# AG-CAT SERVICE NOTES and BULLETINS

**GRUMMAN** AMERICAN AVIATION  
CORPORATION

AG-CAT SERVICE BULLETINS

## SERVICE BULLETIN INDEX

ENGINEERING CHANGE ORDER						CHG. LET.
TITLE:	SWITCH - REWORK of MAGNETO IGNITION					
CHG. INC.	EFFECTIVITY	12100 AC ONLY	PARTS AFFECTED	✓	ECO. SERIAL	S164-703
BY	CARD POSTED	AKK 10-9-61	TOOLS AFFECTED	✓	D.C.R. SERIAL	—
DATE	CHECKED	ES 10-19-61	STOCK DISPOSITION	USE	DWG. NO.	A1892A

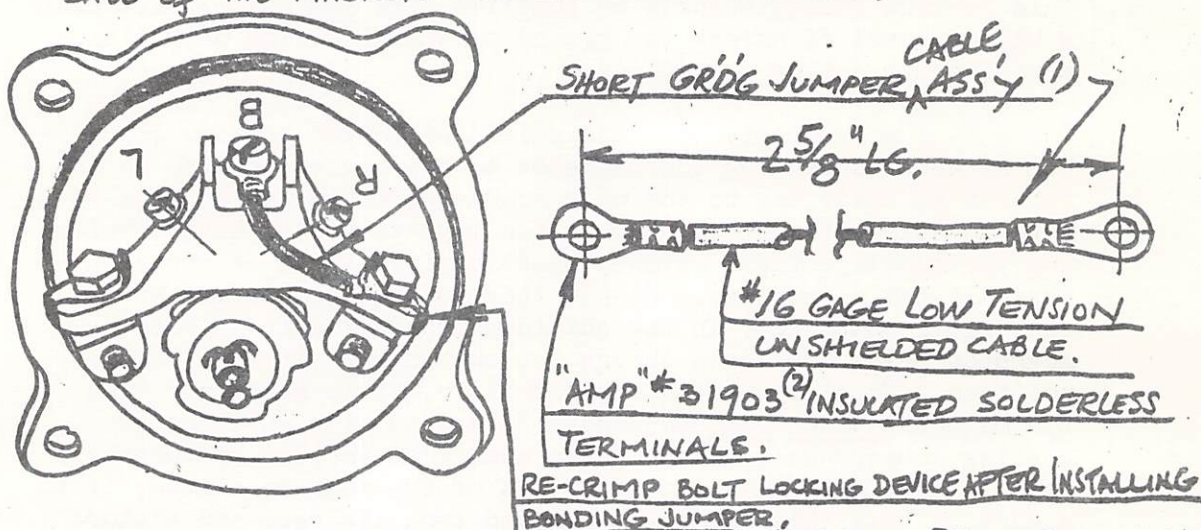
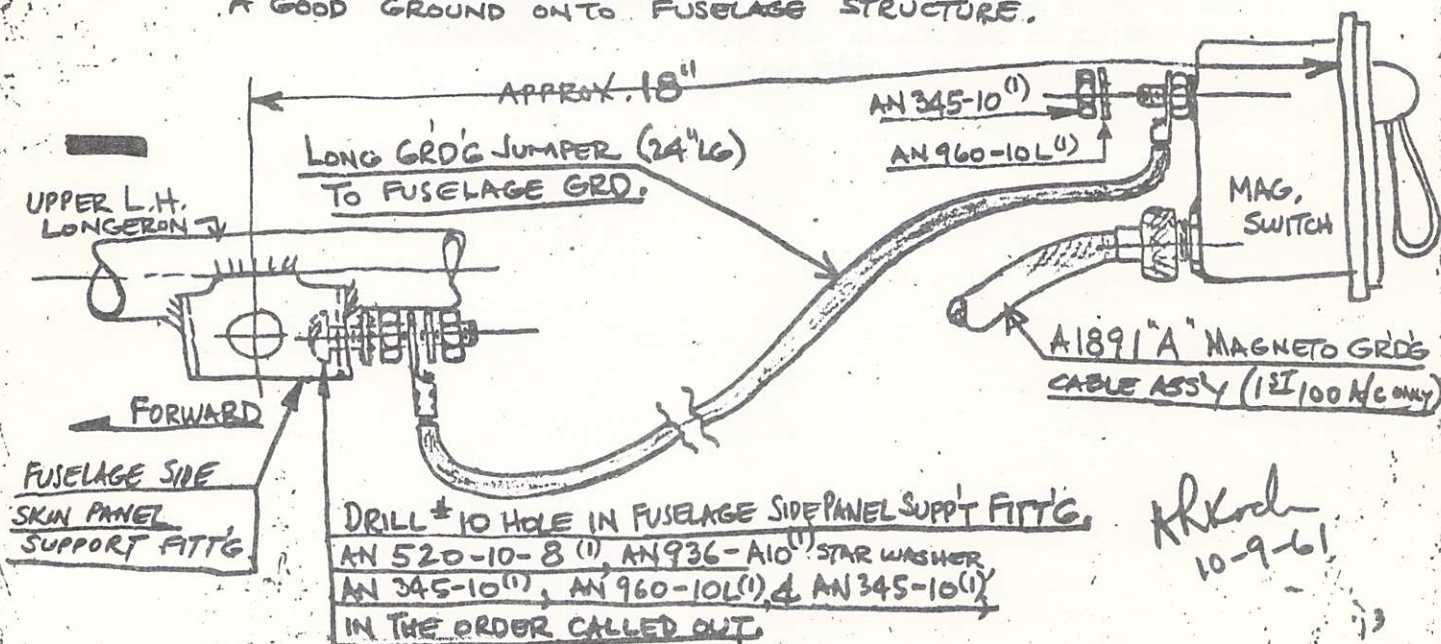
1. THIS CHANGE IS MANDATORY!
2. INSTALL SHORT BONDING JUMPER (DETAILED BELOW) INSIDE THE CASE OF THE MAGNETO SWITCH AS SHOWN BELOW:-

3. AFTER INSTALLING ABOVE INTERNAL JUMPER CABLE, RE-INSTALL MAGNETO SW. DUST COVER & RE-MOUNT MAG. SWITCH ON COCKPIT PANEL.

4. ADD LONG GROUNDING JUMPER CABLE ASSY (MADE UP SAME AS SHORT GRD JUMPER IN (2) ABOVE, EXCEPT THAT CENTER TO CENTER LENGTH IS 24" LONG) & INSTALL AS SHOWN BELOW TO ASSURE A GOOD GROUND ONTO FUSELAGE STRUCTURE.

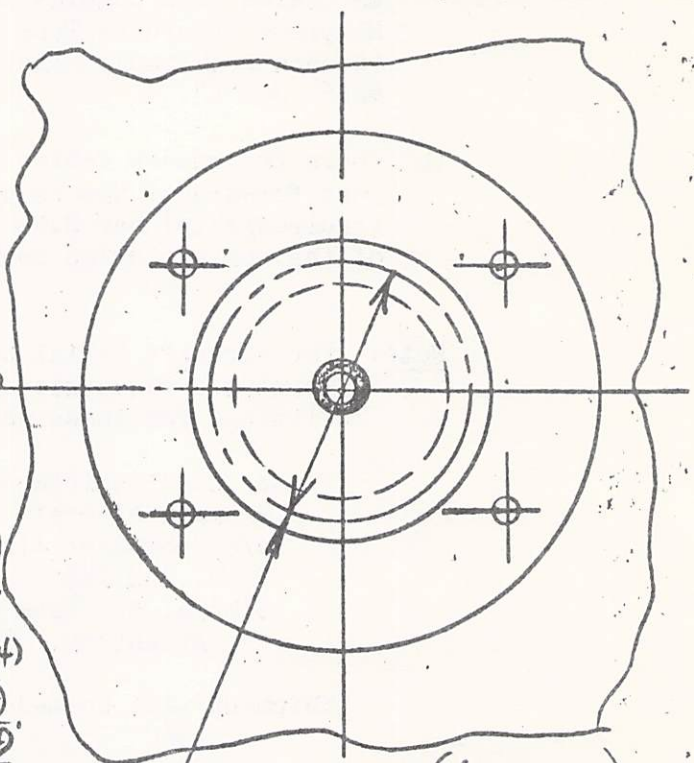
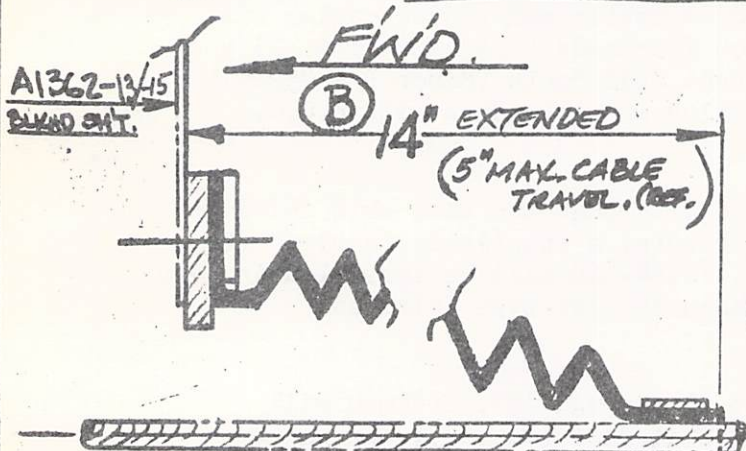
① SECTION "D-D" — (LIMIT TO A/C #50 THRU 125<sup>\*</sup> INCLDG A/C #43)

② ADD SECTION "D'-D'" (AS BELOW) FOR A/C 126 & UP PLUS SPARES ON 131/125A/C

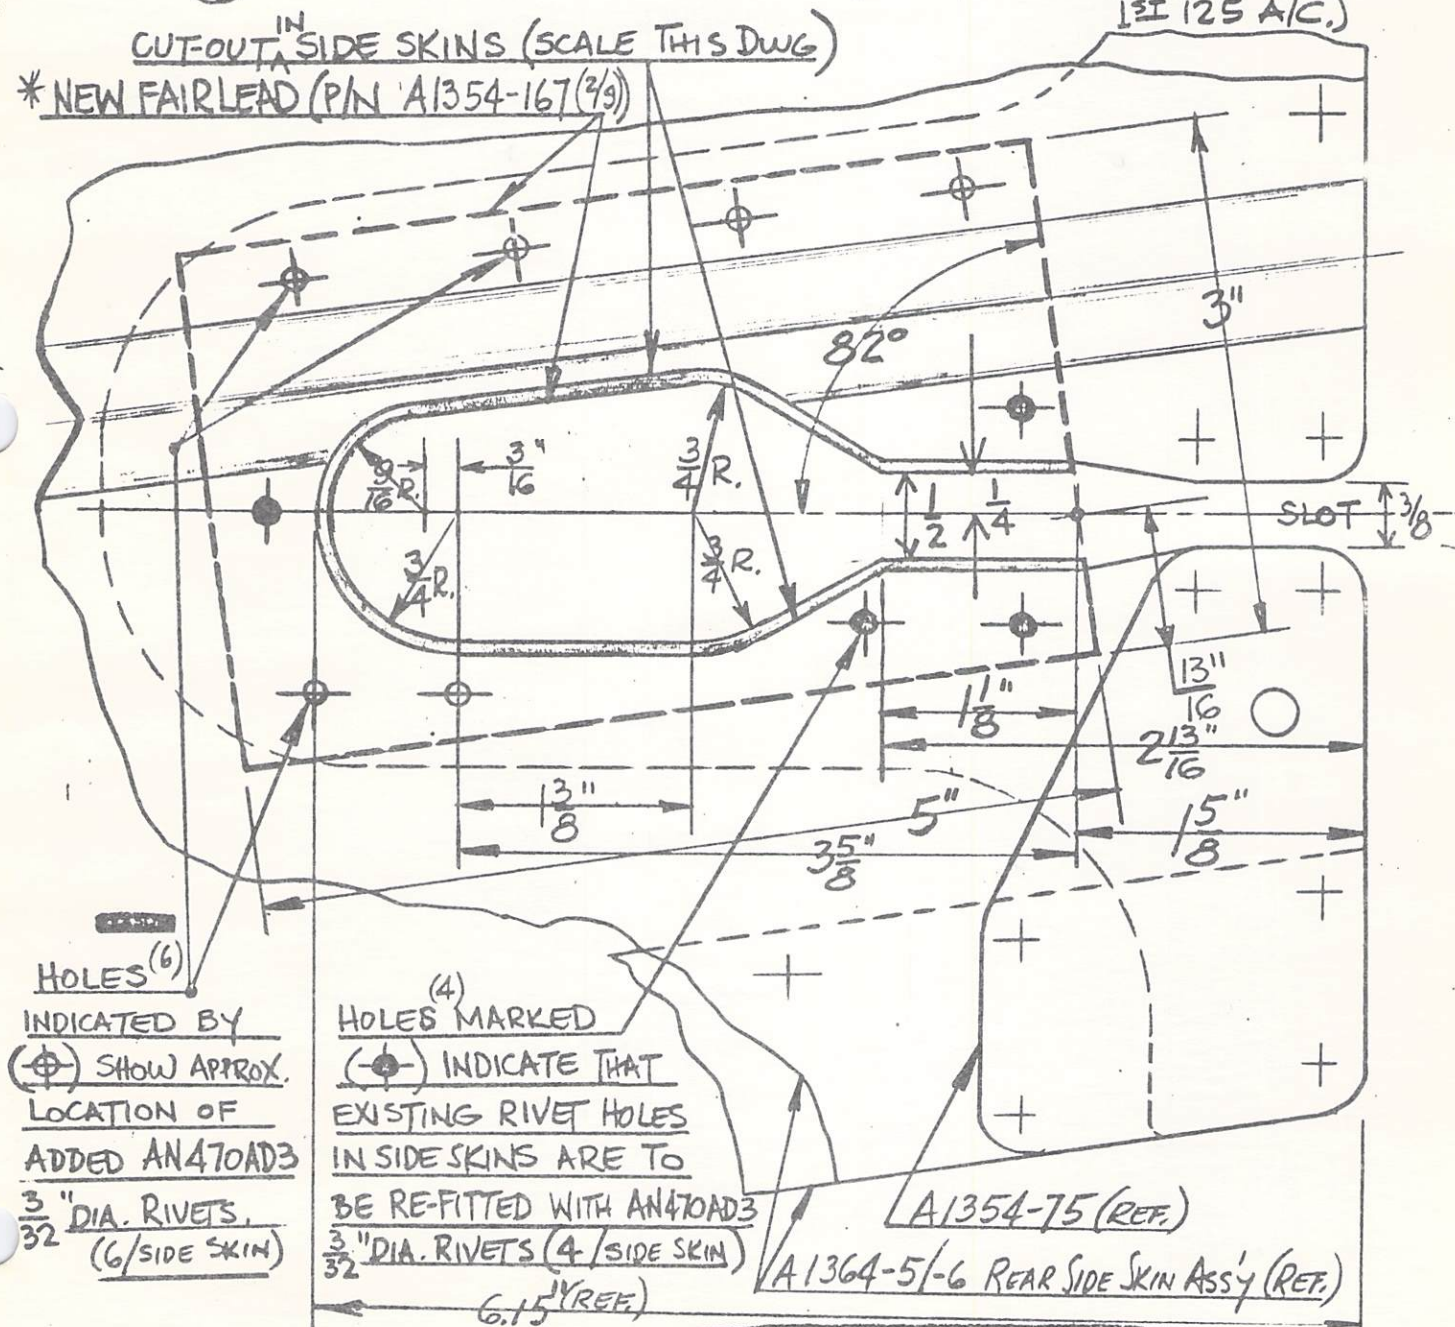
- ① LIMIT E.C.O. #5164-574 TO 1<sup>ST</sup> 125 A/C,
- ② THIS E.C.O. APPLIES TO A/C #126 & UP. (BACK-FITTING IS OPTIONAL ON THE 1<sup>ST</sup> 125 A/C.)

HOLES (6) /  
INDICATED BY  
(Φ) SHOW APPROX.  
LOCATION OF  
ADDED AN470AD3  
3/32" DIA. RIVETS.  
(6/SIDE SKIN)

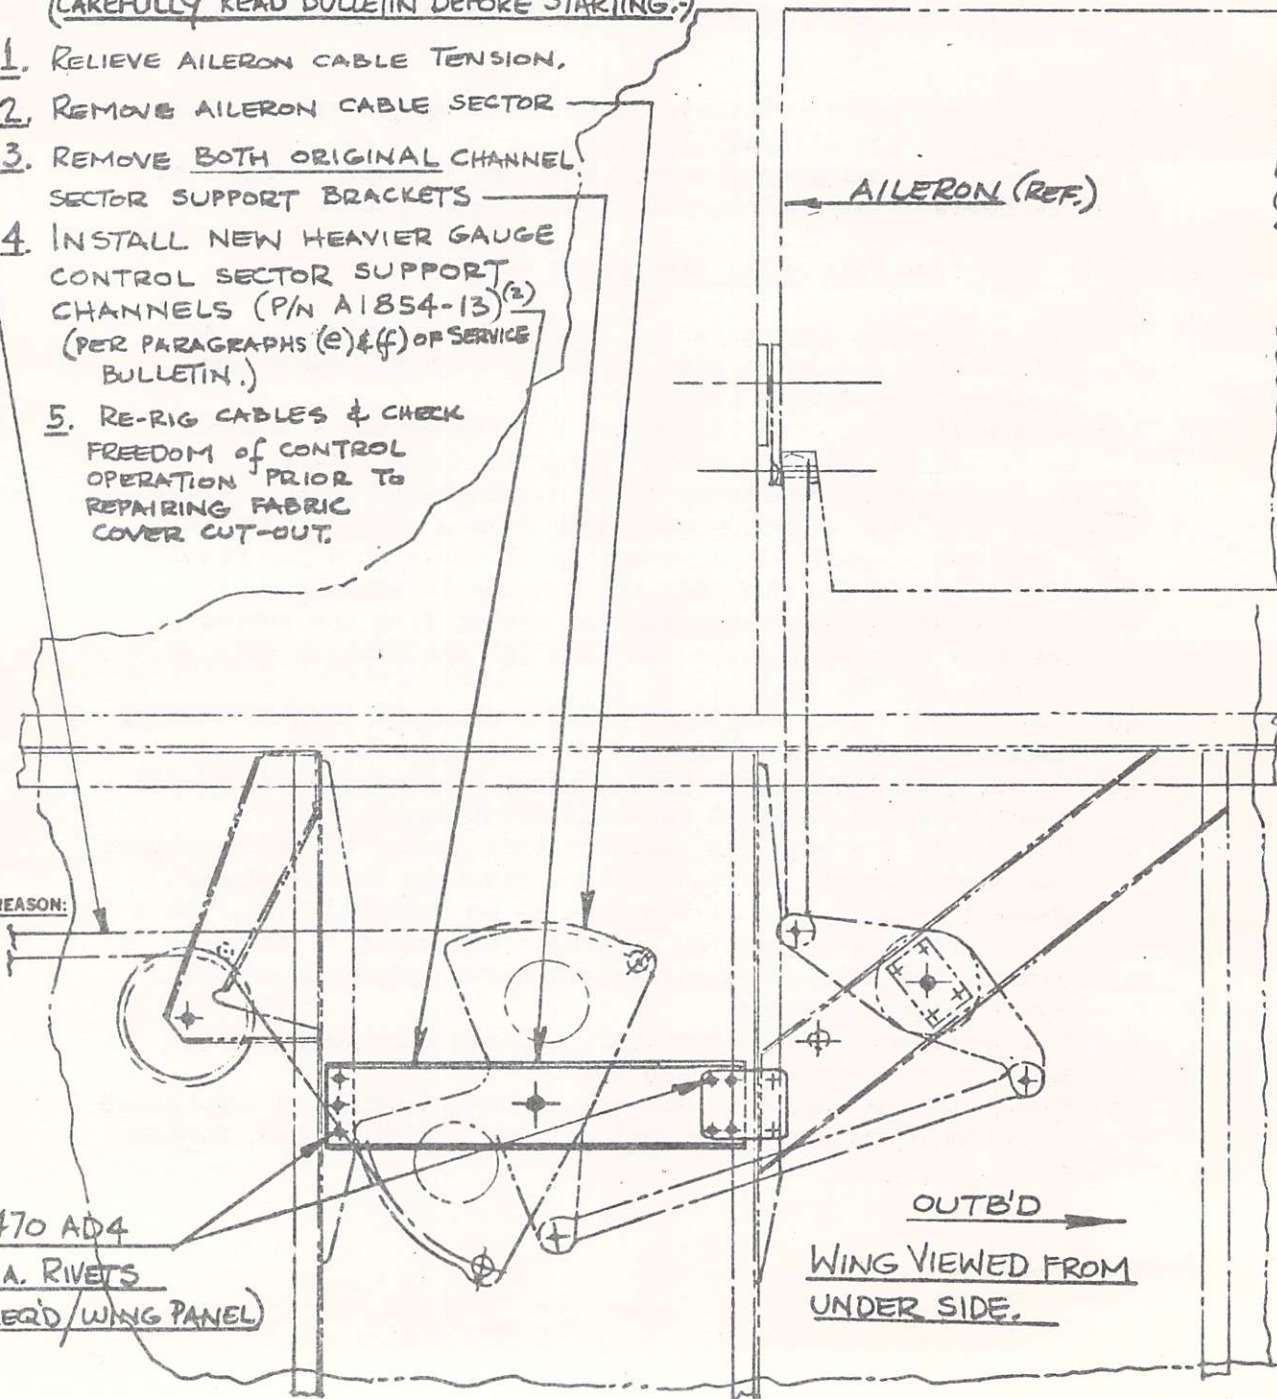
THIS E.C.O. IS WRITTEN TO SHOW THE EXTENT OF REWORK REQ'D BY MANDATORY SERVICE BULLETIN #20, (1-24-62)

1. RELIEVE AILERON CABLE TENSION.
2. REMOVE AILERON CABLE SECTOR
3. REMOVE BOTH ORIGINAL CHANNEL SECTOR SUPPORT BRACKETS
4. INSTALL NEW HEAVIER GAUGE CONTROL SECTOR SUPPORT CHANNELS (P/N A1854-13)<sup>(2)</sup> (PER PARAGRAPHS (E) & (F) OF SERVICE BULLETIN.)
5. RE-RIG CABLES & CHECK FREEDOM OF CONTROL OPERATION PRIOR TO REPAIRING FABRIC COVER CUT-OUT.

ENGINEERING CHANGE ORDER							CHG.	
TITLE:	GEAR INSTALLATION - MAIN LDG GEAR						LET.	
CHG. INC.		EFFECTIVITY	NOTED	PARTS AFFECTED	✓	ECO. SERIAL	S164-1273	
BY		CARD POSTED	ARK 6-11-63	TOOLS AFFECTED	✓	D.C.R. SERIAL	—	
DATE		CHECKED	6-13-63	STOCK DISPOSITION	REWORK	DWG. NO.	A1500 "A"

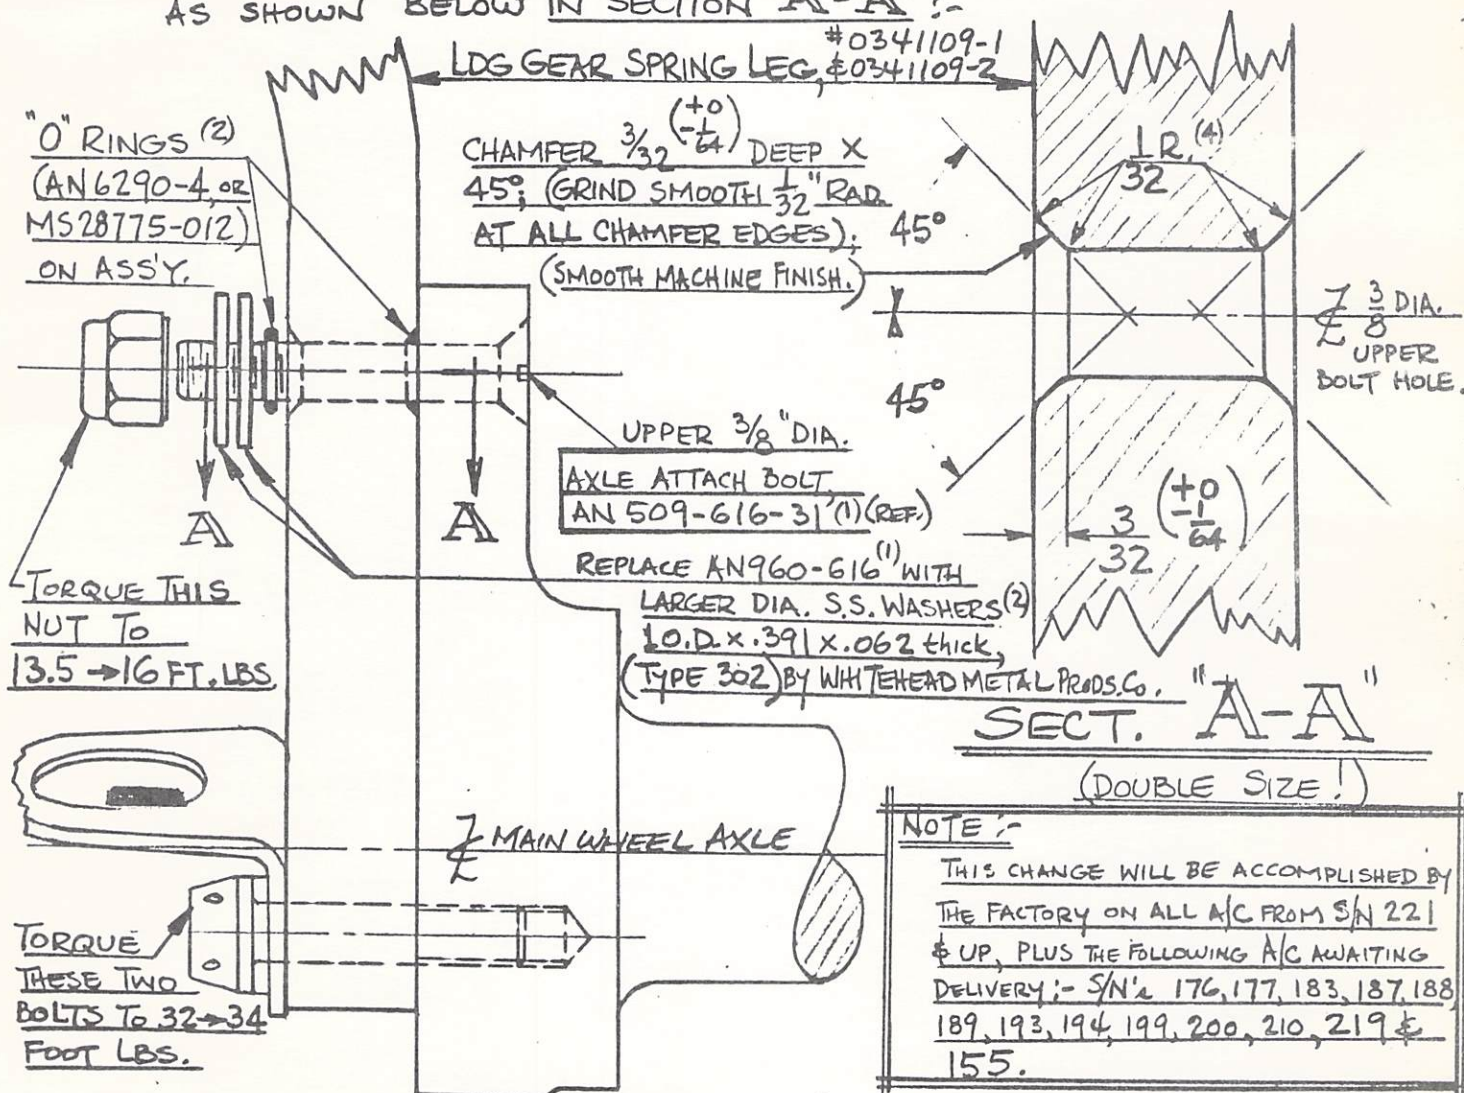
1. RE-WORK MAIN LDG GEAR SPRING LEG UPPER AXLE BOLT ATTACH HOLE  
 AS SHOWN BELOW IN SECTION "A-A" :-

2. AFTER RE-CHAMFERING BOTH ENDS OF UPPER BOLT HOLE, APPLY NON-FLOURESCENT DYE CHECK PENETRANT (BY SPRAY OR BRUSH) TO A CLEAN, OIL-FREE CHAMFERED AREA TO DETERMINE IF SURFACE CRACKS EXIST. IF SURFACE CRACKS SHOW UP ON THIS TEST, REJECT LDG GEAR LEG & INSTALL NEW ONE. TURCO PRODUCTS, INC. (CHEMICAL PROCESSING COMPS) OF HOUSTON, CHICAGO, N.Y.C., & L.A. CAN PROVIDE A DYE CHECK PENETRANT THAT IS KNOWN AS "TITRAC" IF IT IS AVAILABLE IN A SPRAY FORM CONTAINED THE CASE OF ADDITIONAL

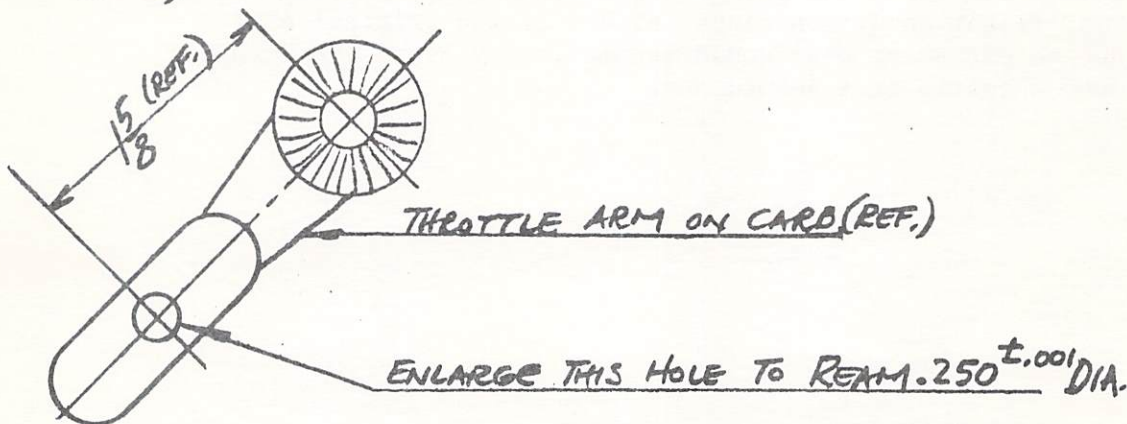
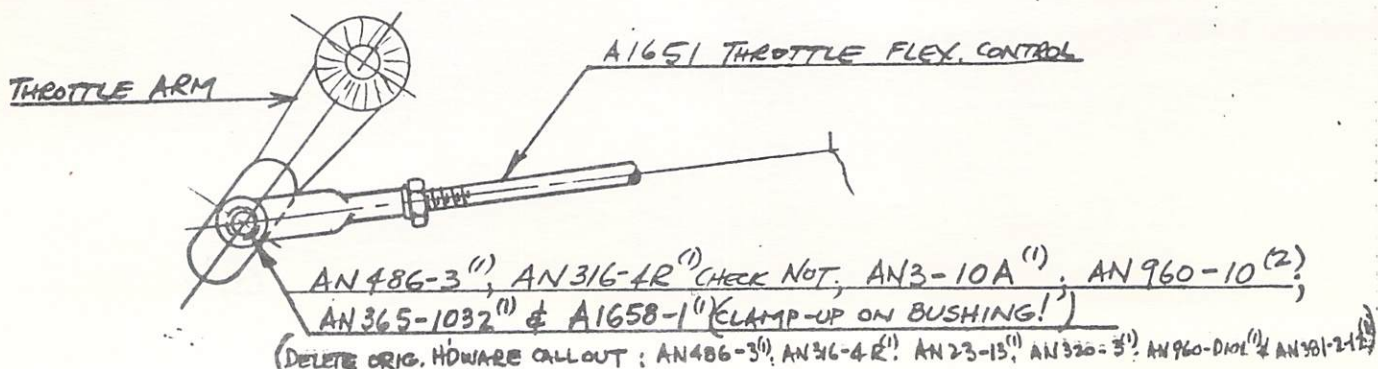
1. RE-DRILL & REAM THE THROTTLE CONTROL ARM (AT THE CARB.) AS SHOWN BELOW :-

2. INSTALL ABOVE THROTTLE ARM ON CARB. & CONNECT THROTTLE CONTROL AS SHOWN BELOW WITH CLAMP-UP BUSH THROTTLE ARM CONTROL CONNECTION :-

ENGINEERING CHANGE ORDER							CHG. LET.
TITLE:	OIL SYSTEM (ASSY & INSTALL.) (JACOBS R-755 ENGINE)						A
CHG. INC.		EFFECTIVITY	ALL	PARTS AFFECTED	✓	ECO. SERIAL	S164-1355A"
BY		CARD POSTED		TOOLS AFFECTED	✓	D.C.R. SERIAL	—
DATE		CHECKED	ARK. 12-10-63	STOCK DISPOSITION	SCRAP	DWG. NO.	A1705"A"

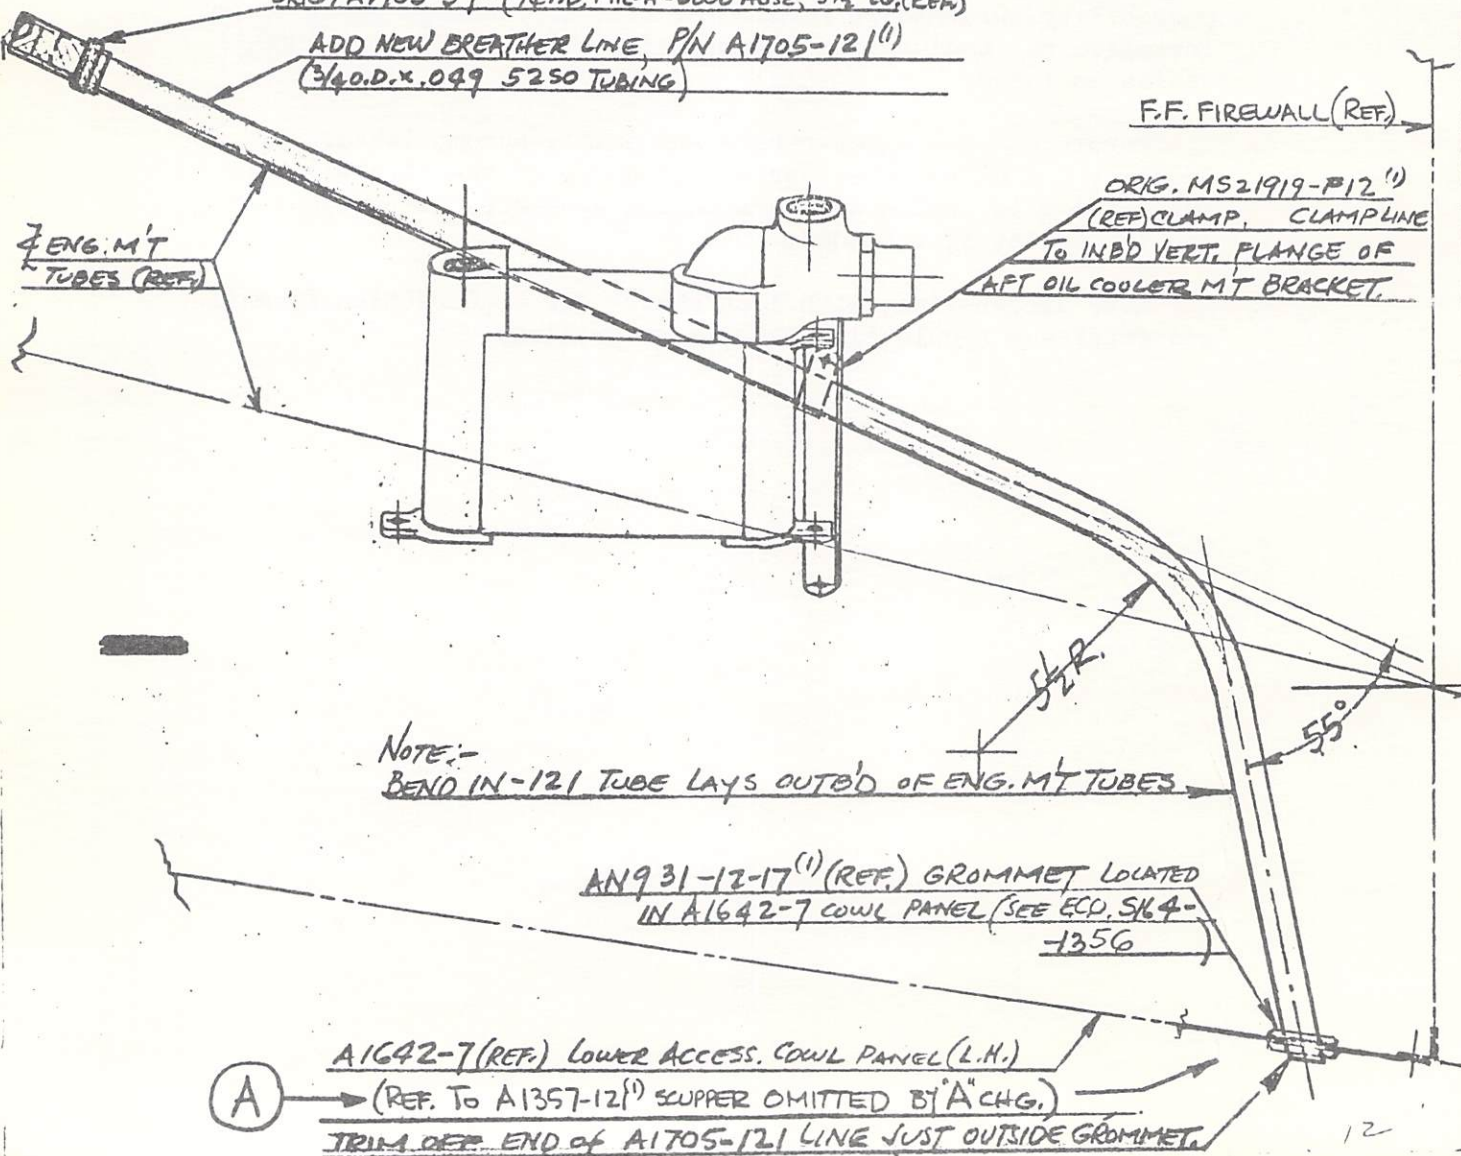
CHANGE: DELETE THE FOLLOWING COMPONENTS OF C'CASE BREATHER LINE :-

CHANGE C'CASE BREATHER LINE COMPONENTS & ROUTING AS FOLLOWS :-

"B" CHG:- REMOVE P/N A1357-121<sup>(1)</sup>  
SCUPPER FROM CHG "A".  
OMISSION OF SCUPPER MAKES  
INSTALL. LESS LIABLE TO ICING UP.  
A.R.Koch 1-22-64
